Response to August 3, 2005 Office of State Planning Coordination Request for Review Letter

RE: PLUS review – PLUS 2005-07-16; Harlton Property

According to the information received, you are seeking site plan review for 197 residential units on 90.56 acres located in the Environmentally Sensitive Developing Area.

SHEET NUMBER: **PP-01**

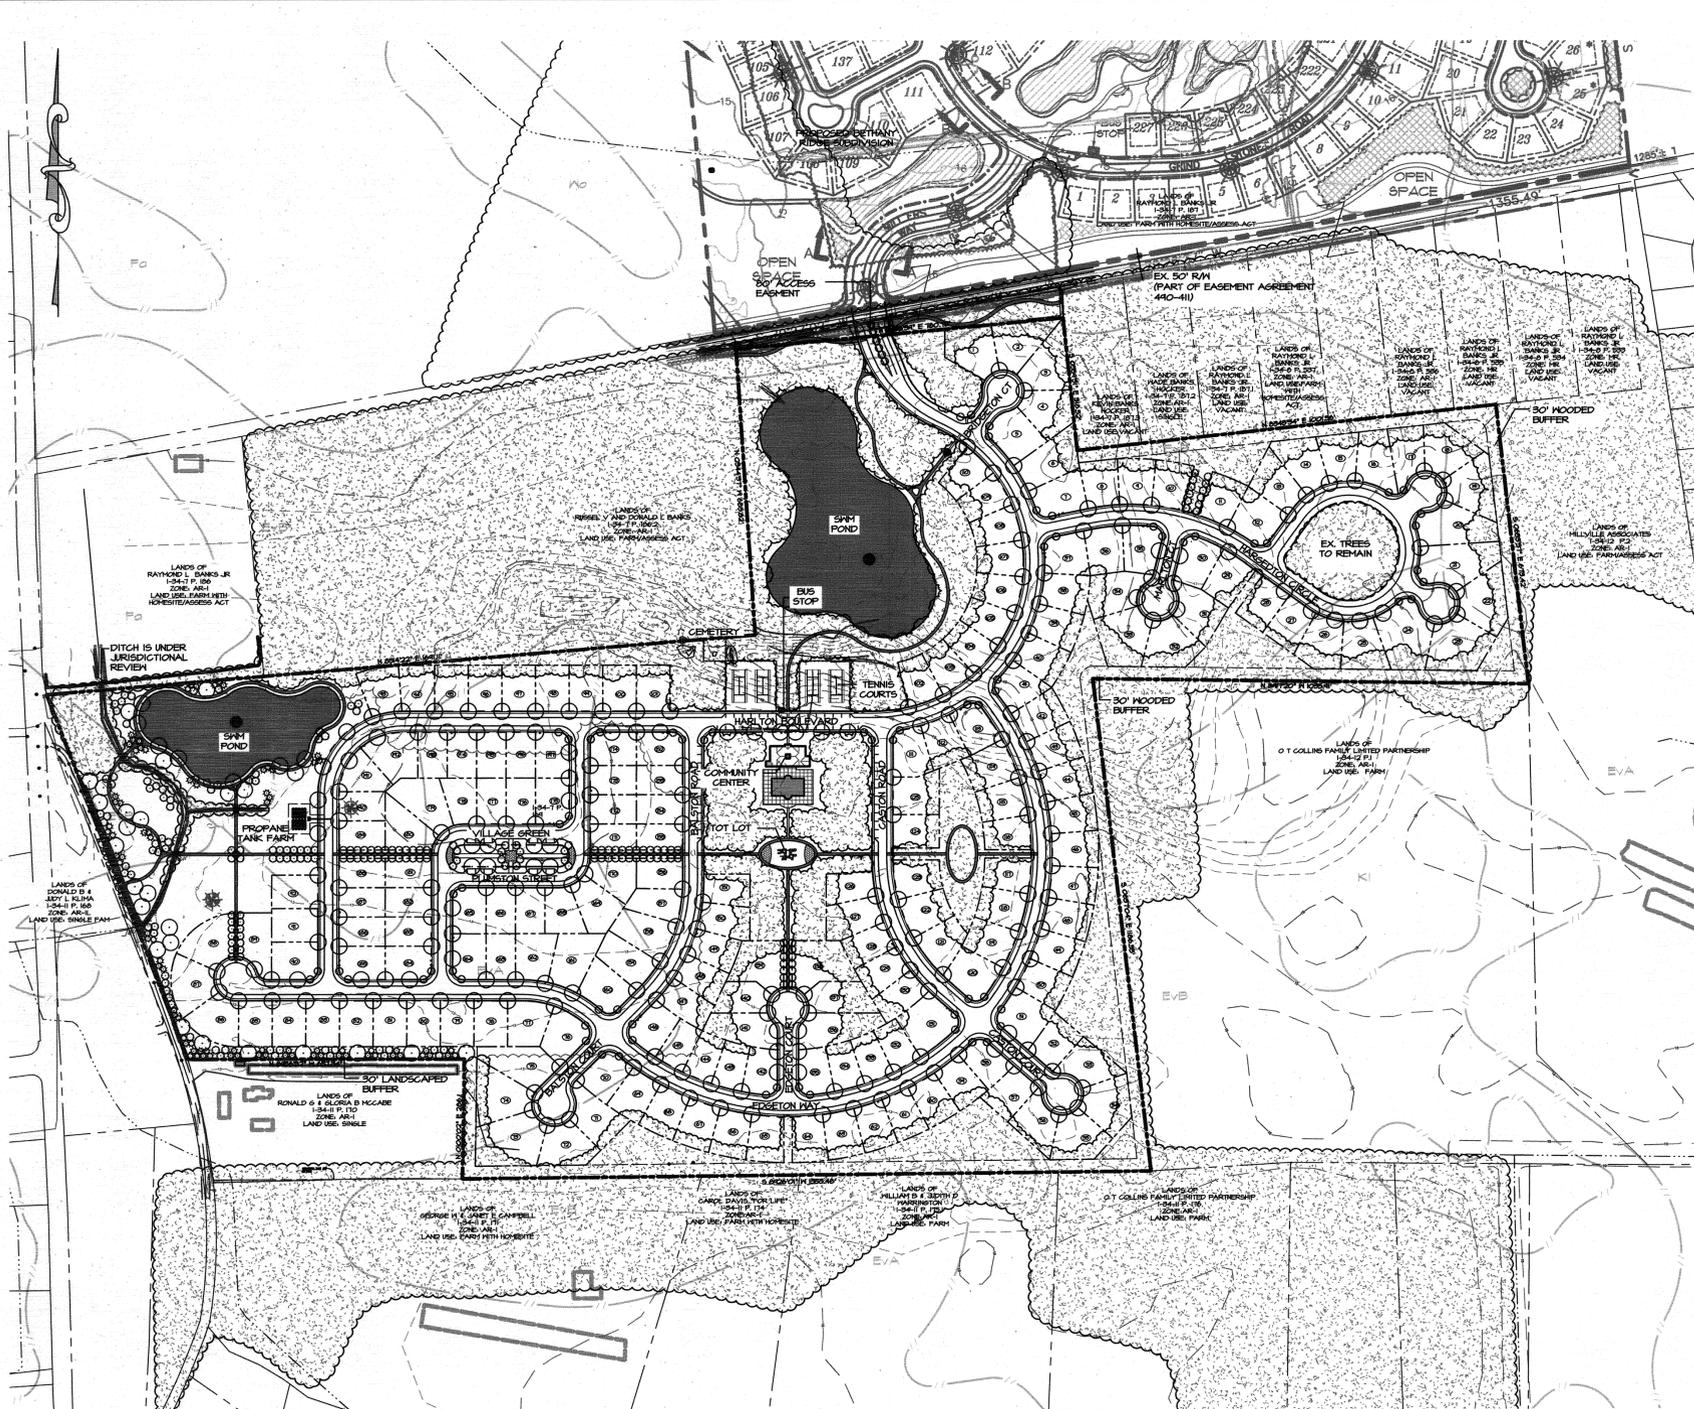
- Four of the eight cul-de-sacs should be eliminated by reconfiguring some of the cul-de-sacs into loops.

- The stormwater management pond should be removed from the forested wetland area of the site for the following reasons:

- The project's design should be modified to focus more effort on preserving forested areas on-site. As currently proposed, at least 39 of the 66 acres of forest would be cleared.

7) DeIDOT recommends that four of the eight proposed cul-de-sacs be eliminated in favor of loops. Specifically, they recommend that Road G be looped back into Road A and that the three cul-de-sacs along Road B from Road C to Road D be reconfigured into a loop. They understand that cul-de-sacs are necessary in some instances to make efficient use of the land where there are environmental constraints. However, they are not conducive to good traffic flow or a sense of community. Where possible they should be eliminated.

Secondly, there is a stormwater management pond proposed in the wooded area adjacent to wetlands. This pond should be removed as it does not make sense to clear trees to create ponds considering the benefit trees have in flood abatement and erosion control. Also, stormwater management ponds should not be located within 100 feet of wetlands. The water quality within the wetlands could be detrimentally affected by infiltration or overflow of water from adjacent ponds. The water quality within these ponds are often high in nutrients and contain run-off from landowner activities (car washing, oil changes, chemicals used in home maintenance, etc.).

Upon considering the redesign of the street layout, it was found that replacing the cul-de-sacs with loops would increase impervious surface and forest clearing. The current layout is the most efficient way to provide access and preserve forest. Characteristically, these roads have been conventional features of land plans for decades and desirable locations within developments for many homeowners seeking the benefits of low traffic volume, vehicular speed and accompanying safety for children associated with such. The lengths of roads are within reasonable standards and provide alternative no thru traffic homesites readily available to the main traffic pattern and pedestrians.

This area will remain untouched. To relocate the storm water pond from its current location to an adjacent upland slope would require more grading and tree clearing resulting in disturbance of the specific prehistoric area you want to protect.

Upon considering the redesign of the street layout, it was found that replacing the cul-de-sacs with loops would increase impervious surface and forest clearing. The current layout is the most efficient way to provide access and preserve forest. All on site roads are private and will be constructed by the developer and maintained by the HOA. The developer is uncomfortable opening the site to other unknown potential adjacent Communities and putting a potential future liability on the Homeowners Association. The privacy and containment of the Proposed Community is a design feature that is further reinforced by a 30' buffer between the adjacent properties to help contain and emphasize this private feature.

The wetlands are in the natural low spot of the site facilitating it as a stormwater management location. Placing a similar feature in the adjacent area would not be prudent. It would disturb the natural water table, require clearing more trees, and inevitably affect the wetlands regardless. We agree that for wooded buffers, poorly drained forest plots have been found to provide greater denitrification than well-drained forest plots by creating better living and growth conditions for denitrifying microbes as well as by keeping water within the organically enriched surface soil layer and close to root systems of resident vegetation.

The concept for the forested pond is to direct more of the developed site runoff into the pond. By increasing the water volume and perimeter subaqueous vegetation, more water quality will be provided. A dense forest fringe resulting from increased sunlight and periodic inundation of the more permeable soils around the aquatic bench through storm events will increase the microbial denitrification potential. Additionally, by including more periodically inundated forested fringe accessible by equipment, one could selectively harvest woody-stemmed species thereby permanently removing nitrogen stored in plant tissues that would otherwise reenter the system through decomposition under the current conditions.
